**1333 Davidson Street, Port Douglas – Reconfiguring a Lot (1 Lot into 2 Lots)  
Information Request Response (pursuant to Section 13.2 and 13.3 of the Development Assessment  
Rules)  
Your Ref: ROL 2023\_5442/1**

## Information request response

Figure 1: As- constructed sewer extract

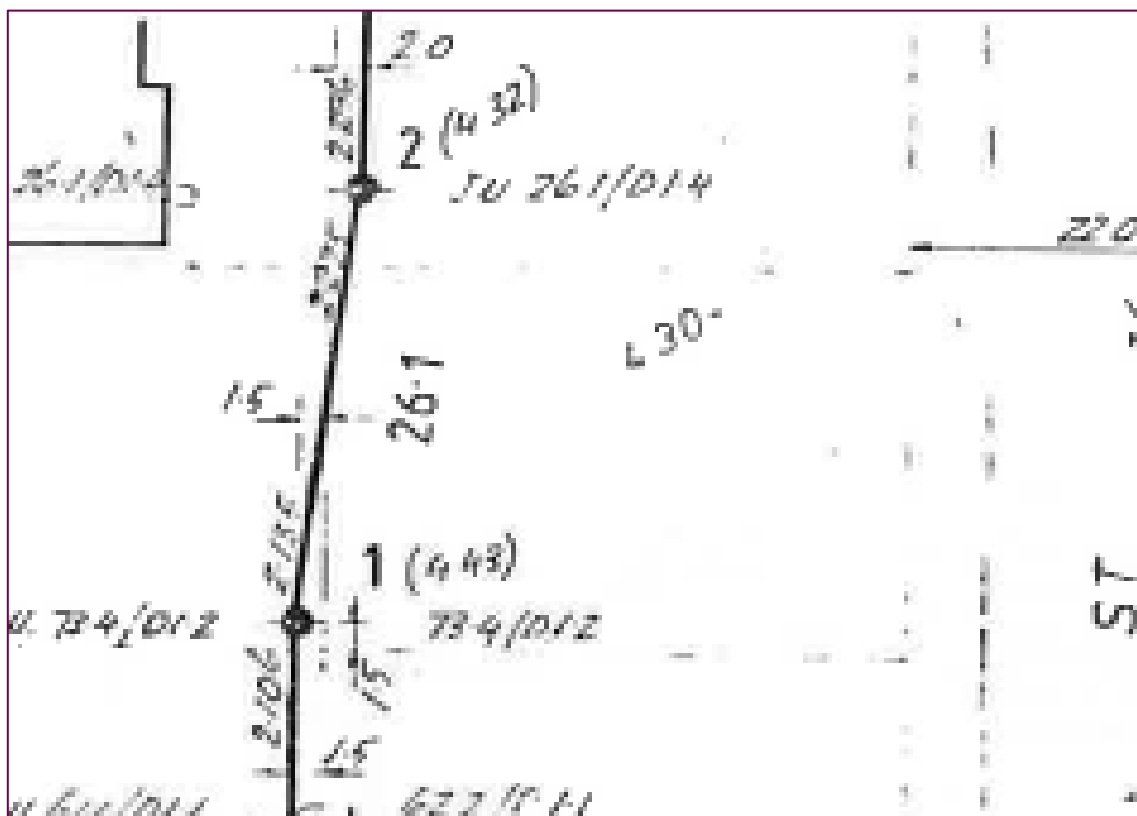
Currently the units share connections and infrastructure for connection to Council's water supply and sewer services. These connections appear to be at the rear of the units and will be encumber each lot.

2. Please provide a plan detailing the proposed new connections (including connection points), service infrastructure and the location and extent of easement area to encumber each new lot.

In respect of sewer, a review of the As Constructed drawings indicates that a house branch connection is provided in the south western corner of the site, and the sewer line traverses through the rear of the site. The sewer connection is located 1.5 metres from the southern side boundary and is 1.2 metres deep. The location of the sewer connection is illustrated in Figure 1 below:

The house branch connection is able to be upgraded in accordance with the FNQROC requirements and extended along the standard alignment to provide an additional connection point within the easement for proposed Lot 1. It is expected that the separate sewer connections would be required to be provided prior to the endorsement for a plan of survey and any Development Permit conditioned accordingly. Should an easement be required, this could also be provided as part of the plan endorsement application as the creation of a services easement does not require development approval.

### **Building Plans No. 2**

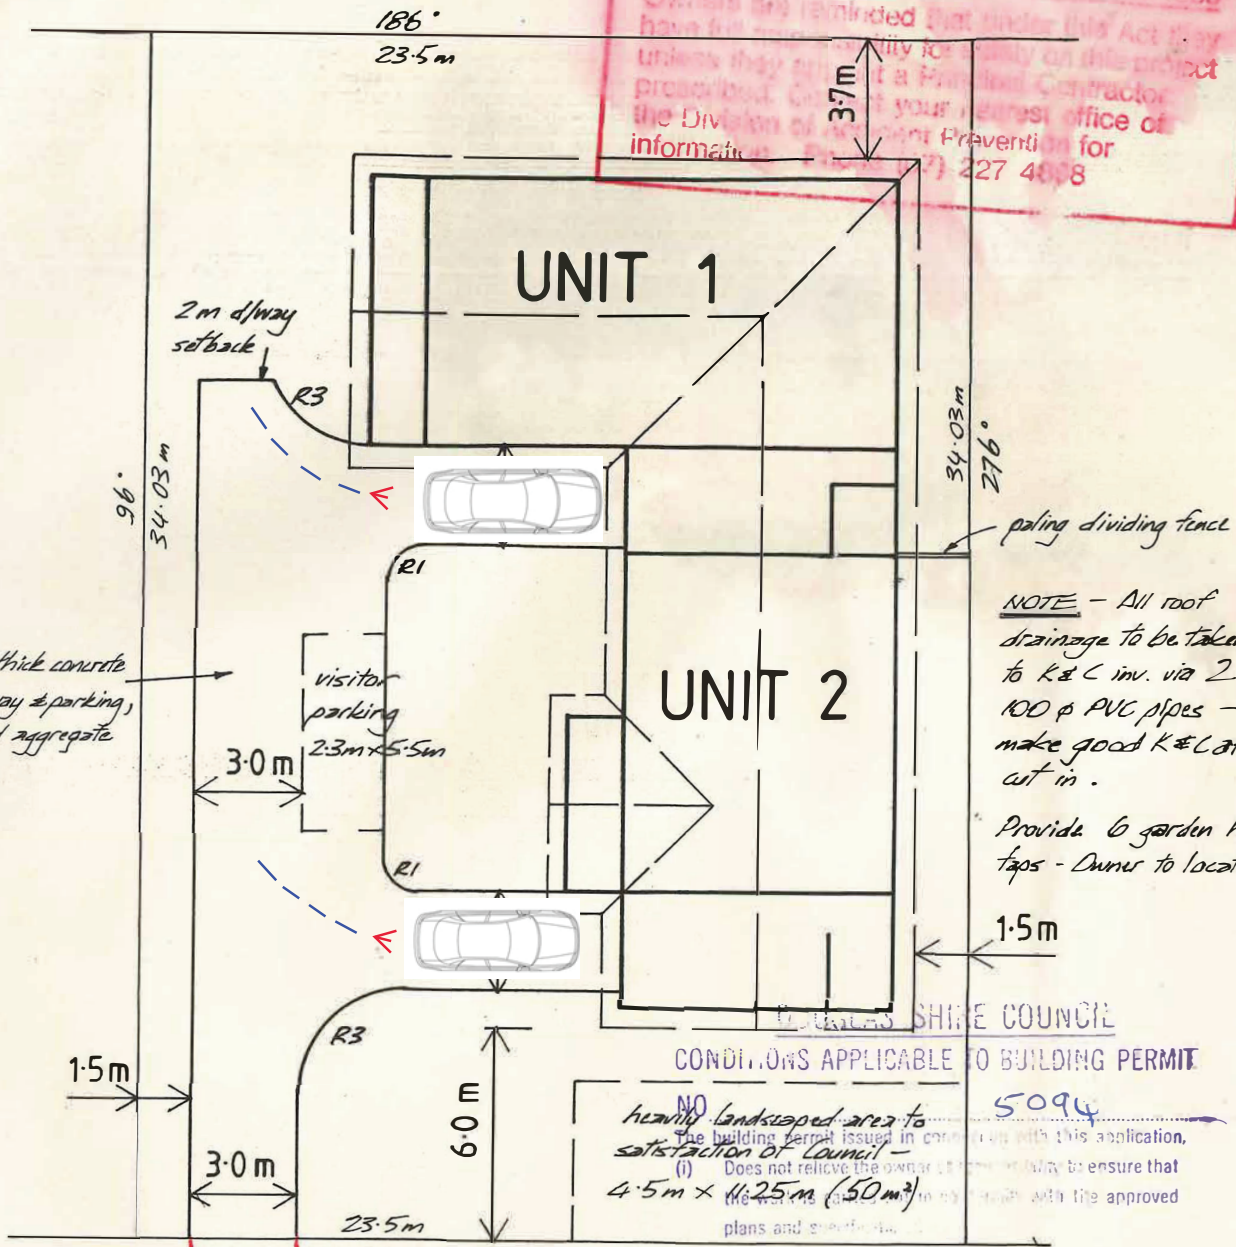
The report states that each lot can accommodate two car spaces.

1. Please provide a scaled site plan detailing the floor plan of each unit, the two car parking spaces for each unit, the turning area to enable each car space to be able to enter and egress from the site in a forward gear and the driveway area.

The resultant development would be two standard format lots, each containing a Dwelling House. In accordance with the Acceptable Outcomes of the Douglas Shire Planning Scheme, two car parking spaces should be provided per Dwelling House, which may be in tandem. Each of the attached dwellings has sufficient car parking for two (2) vehicles. One (1) vehicle parked in the existing garage and the second vehicle parked immediately behind the garage in tandem.

The existing driveway and access arrangements provides sufficient area for vehicle manoeuvring to facilitate vehicle ingress and egress in forward gear from Davidson Street. The subject site also provides an additional area for one (1) visitor car park.

The existing car parking arrangements for each dwelling are depicted on Building Plan No. 2, provided for reference as **Attachment 1**.
